SERVICE BULLETIN
SUMMARY

**TITLE: AIR CONDITIONING - CONDITIONED SERVICE AIR SYSTEM - INSTALL
IMPROVED CSAS CONTROL UNIT (CCU-K06)**

A318/A319/A320/A321

MODIFICATION No.: 153186K15493

Figure A-GBAAA - Sheet 01
Replace the CCU

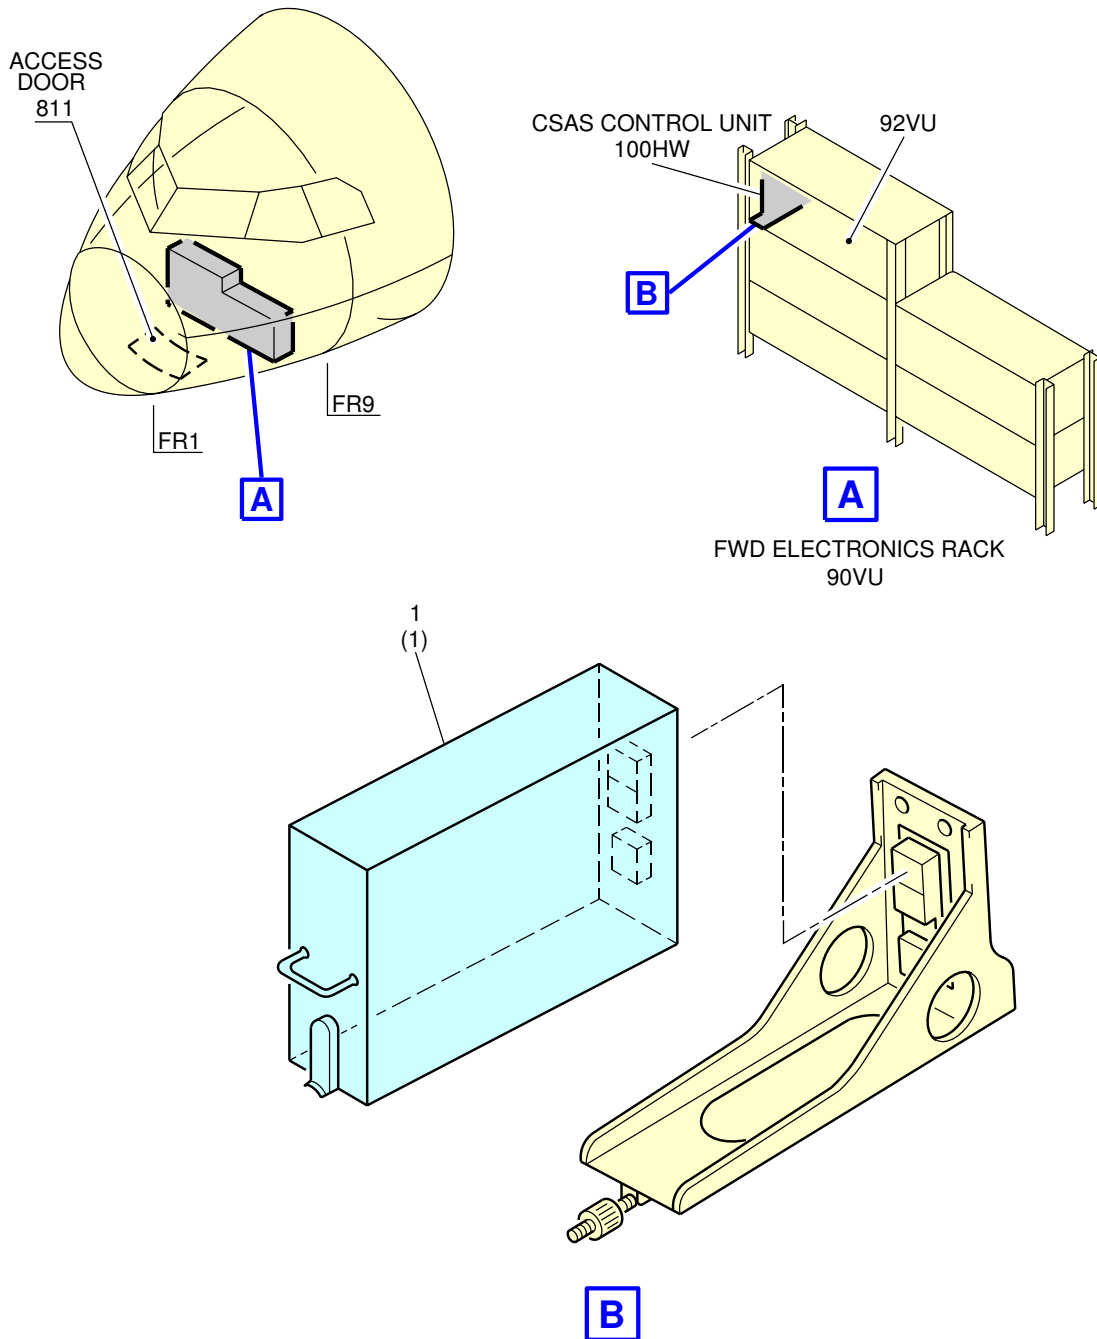
- (a) As shown on [Fig. A-GBAAA Sheet 01](#), remove the CCU 100HW, (Refer to AMM Task 21-58-34-000-001).

- (a) As shown on [Fig. A-GBAAA Sheet 01](#), install the CCU 100HW, (Refer to AMM Task 21-58-34-400-001).

- (a) Modify the CCU 100HW, (Refer to LIEBHERR AEROSPACE Service Bulletin No. 3959A-21-03).

- (b) After the modification the Part Number (PN) of the CCU will change as given below:
